**ADDENDUM NO. 1 -** Distributed via email and posted on the City of Burlingame website at: www.burlingame.org/washingtonplayground

Washington Park Playground, Sports Court, & Picnic Area - City Project Number 85670

Addendum Issue Date: 04/18/2019

**L2.0**

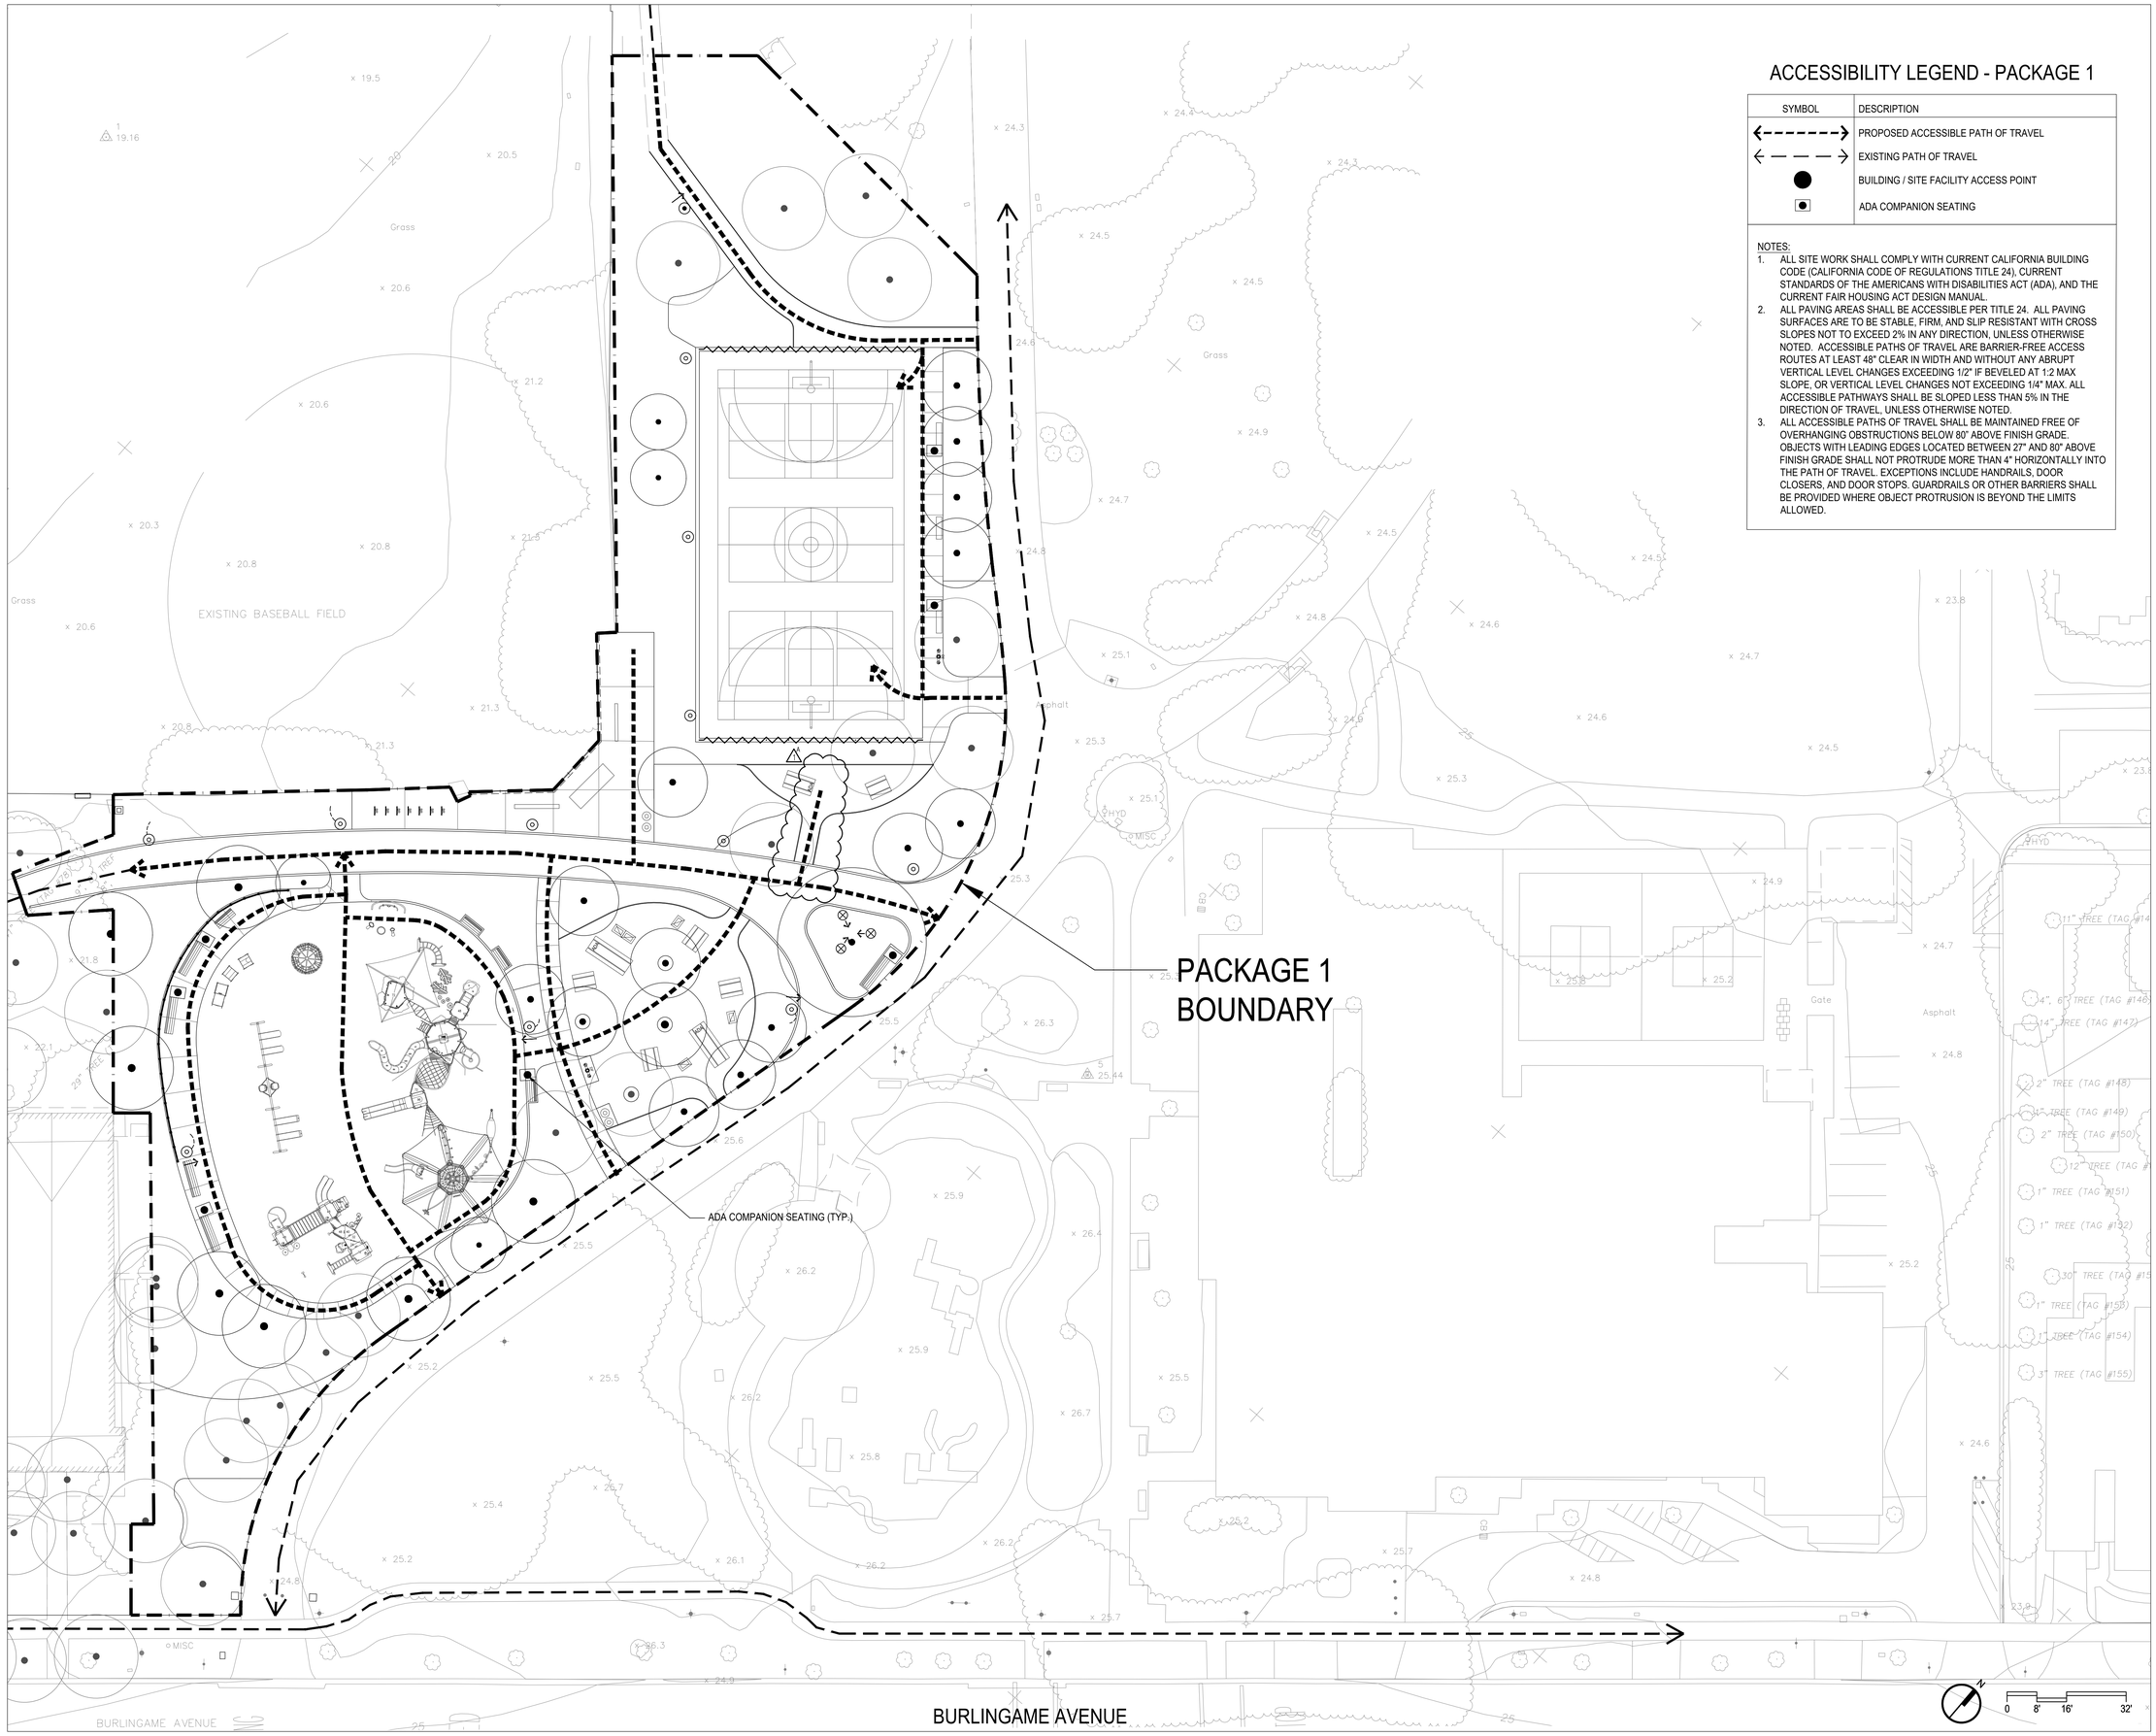
20. **Sheet L2.0:** 5 foot-wide accessible path added for picnic area south of multi-use court.
21. **Sheet L3.1:** Picnic area south of multi-use court expanded configuration and 5 foot-wide access path revised with stabilized decomposed granite (dg) replacing a portion of the turf. Wood header to define stabilized dg. Reduction of turf. Benches installation embedded per detail 7/L4.2.

## 1 ASPHALT PAVING (PEDESTRIAN)
SCALE: 1-1/2" = 1'-0"

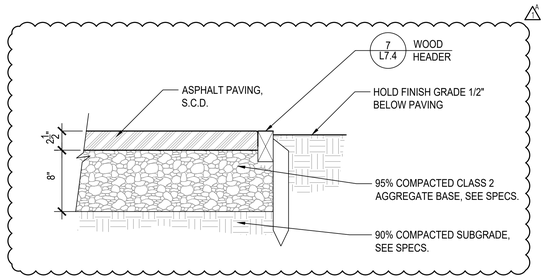
24. **Sheet L3.2:** Per City plan check comment, added note see Layout Plans L5.1 and L5.2 for dimensions.
25. **Sheet L4.0:** Revised detail 1/L4.0, compacted aggregate base increased to 8 inches for loading purposes.

**L5.1**

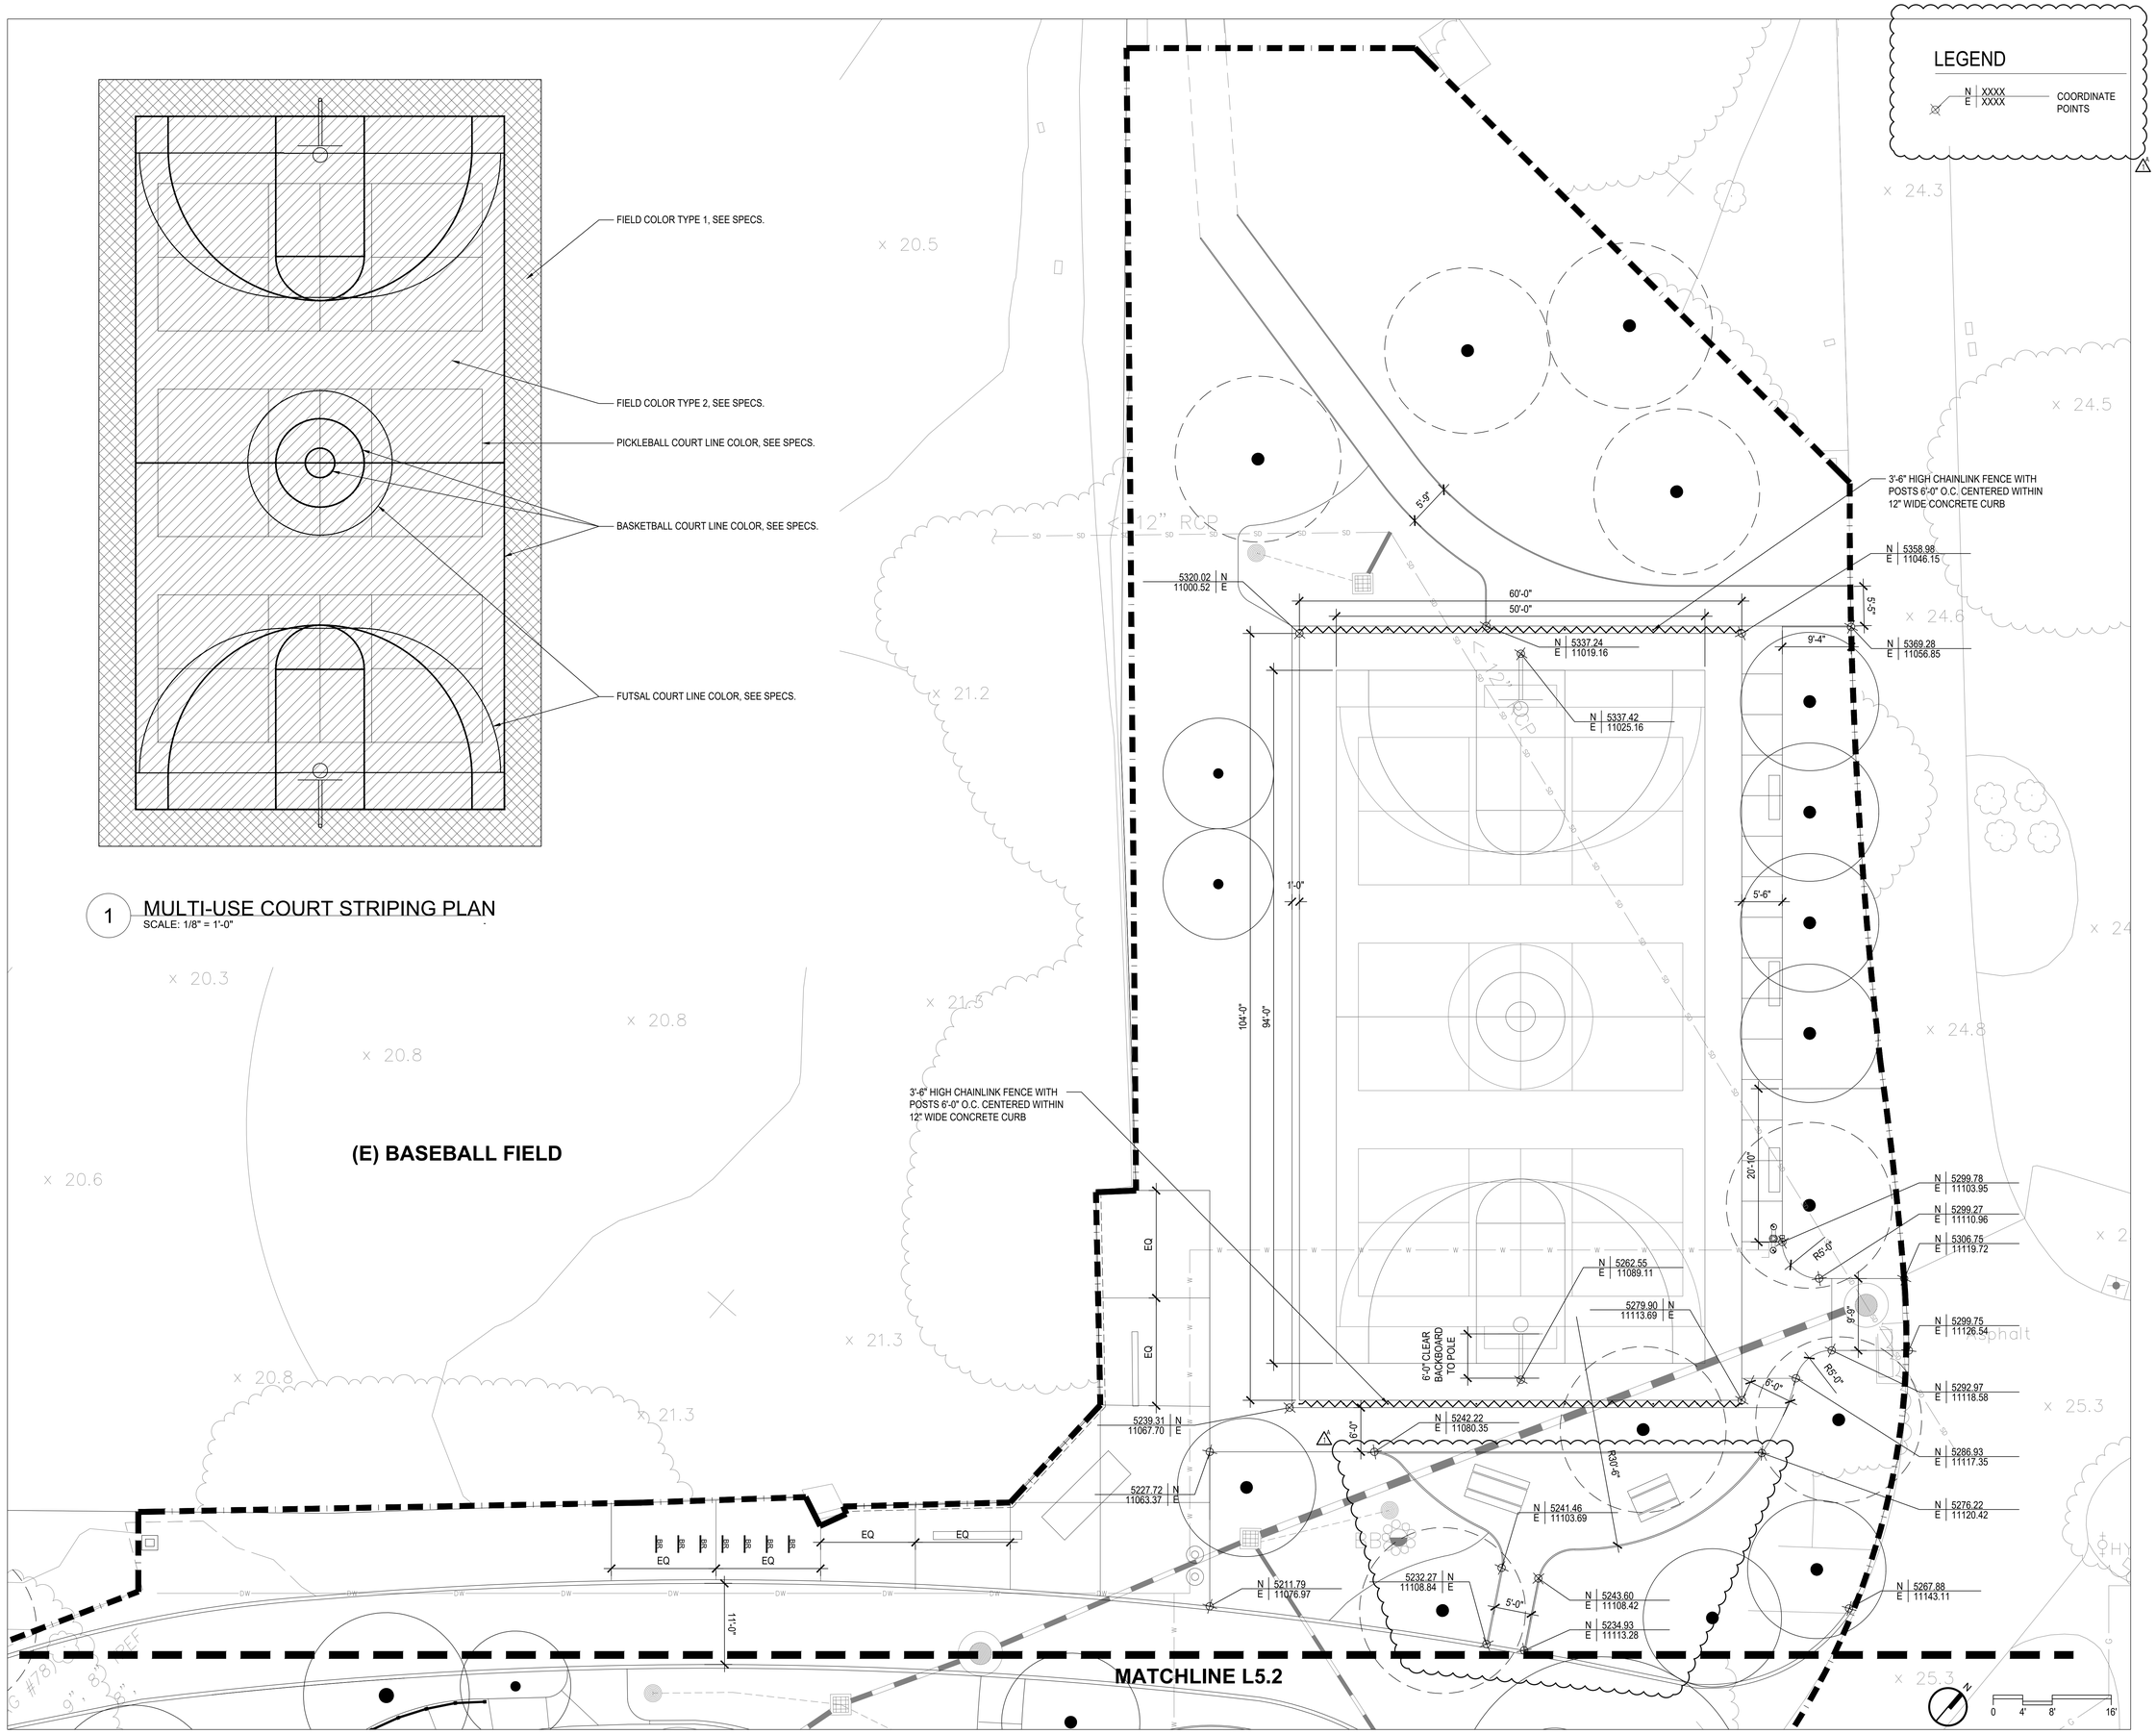
28. **Sheet L5.1:** Added dimensions and coordinate points for picnic area configuration.
29. **Sheet L5.1:** Added legend of coordinate points per plan check comment.
